REGIONAL REVIEW NOTICE

ARC REVIEW CODE: R14052101

Name of Proposal: Braves Stadium and Mixed Use Development

SUBJECT: **Transportation Division Review of DRI # 2381**
Project: Atlanta Braves Stadium and Mixed-Use Development
County: Cobb
Location: Block bordered by Circle 75 Pkwy to the South and East, Windy Ridge Pkwy to the North, and Cobb Pkwy/US 41 to the West
Analysis:
Expedited ☐
Non-Expedited ☒

Figure 1: Pedestrian Connection between “South Parking” and Braves Development Site

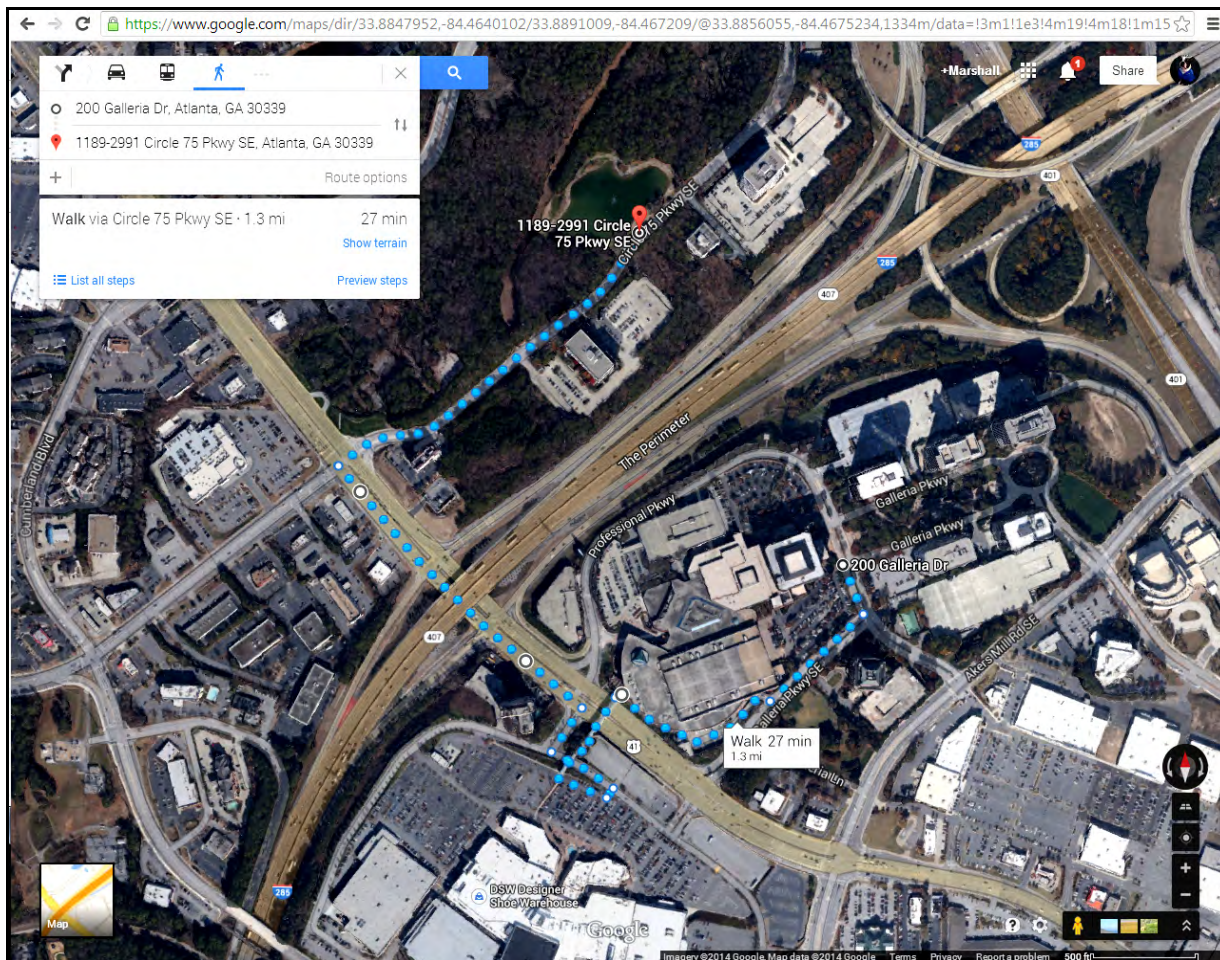
Approximately 35% of vehicles will park in the “South Parking” area (see Figure 7 in the Transportation Analysis submitted by Kimley-Horn & Associates). The pedestrian connection from that area’s midpoint to the Braves stadium is a 1.3 mile walk (27 minutes). There is no sidewalk on the northbound side of Cobb Parkway between the Cobb Galleria complex and the I-285 West exit ramp at Cobb Pkwy, thus requiring pedestrians to cross Cobb Pkwy via the Cobb Galleria/Cumberland Mall pedestrian bridge and then cross again at Circle 75 Pkwy which currently has 11 lanes of travel (the submitted site plan shows 15 lanes). Access from the south of the subject site was not included in the *Bicycle and Pedestrian Facilities* (Section 1.4) of the Transportation Analysis.

- One example is there are no sidewalks on NB side of Cobb Pkwy at I-285. The lack of sidewalks forces those who park in "South Parking" to cross Cobb Pkwy at Cumberland Mall via pedestrian bridge, then cross 11 lanes at Circle 75 Pkwy (the submitted site plan shows 15 lanes). The sidewalk on the SB side of Cobb Parkway may need to be widened to accommodate the large number of pedestrians that will utilize this facility in accessing the site. Cobb Pkwy in this area has an annual average daily traffic of 42,070 (2012 GDOT STARS data).

Figure 2: Pedestrian Connection from Cumberland Transfer Center to Braves Development Site

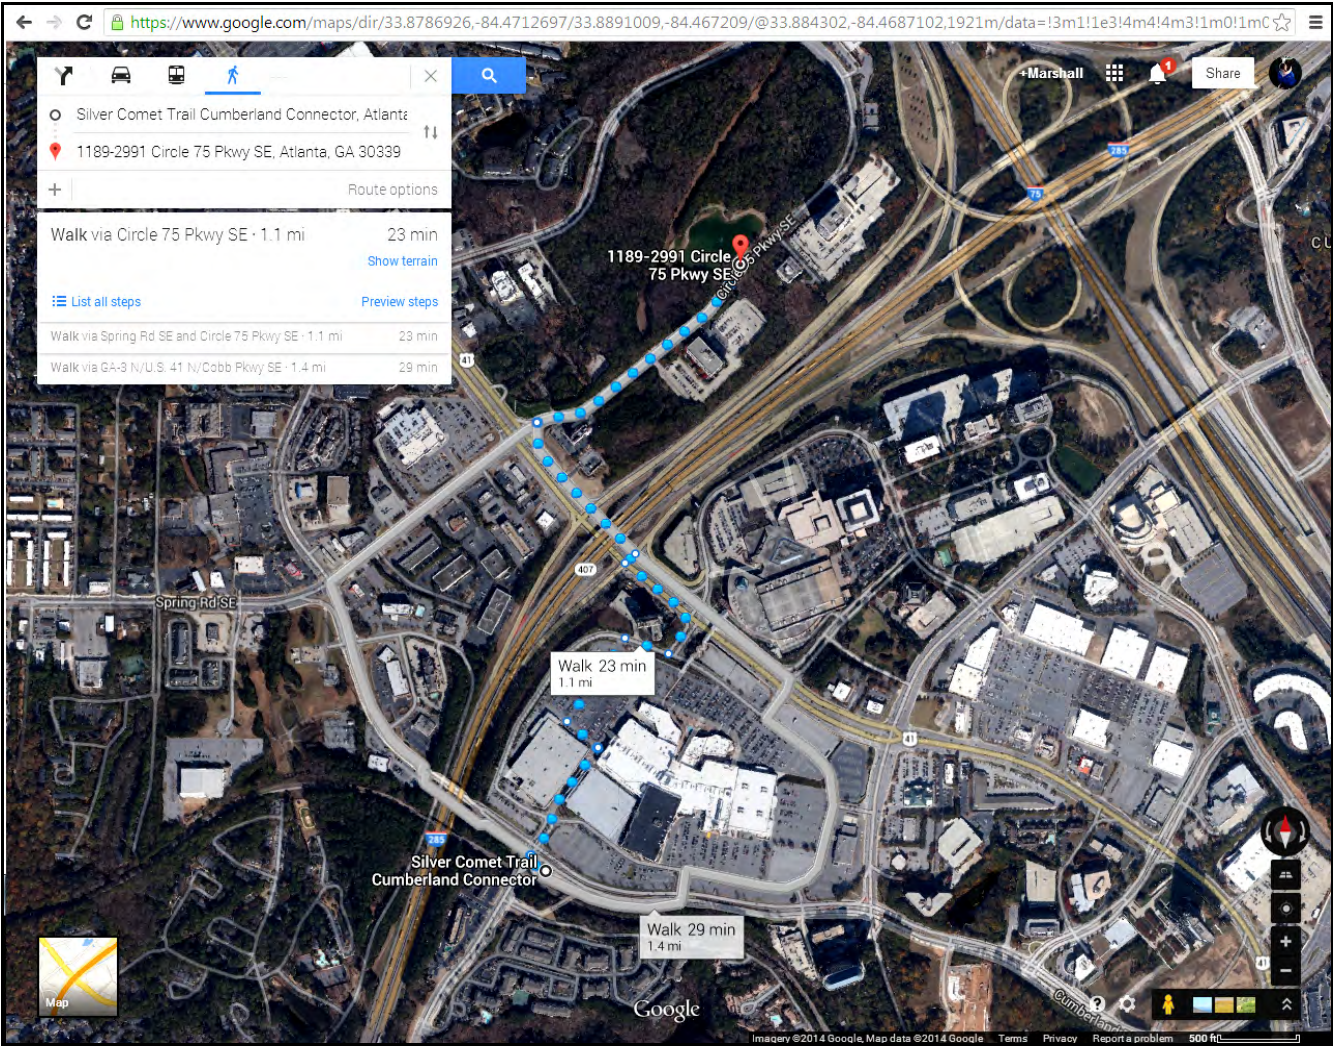
The site is directly served by Cobb Community Transit. The Cumberland Transfer Center is located on the south side of Cumberland Mall and is served by MARTA Bus Route 12 (between Midtown, Atlanta and the Cumberland Transfer Center), and Cobb Community Transit Bus Routes 10, 10A, 10B, 20, and 50. The Cumberland Transfer Center is an approximate 1.1 mile, 23-29 minute walk to the subject site (Figure 2).
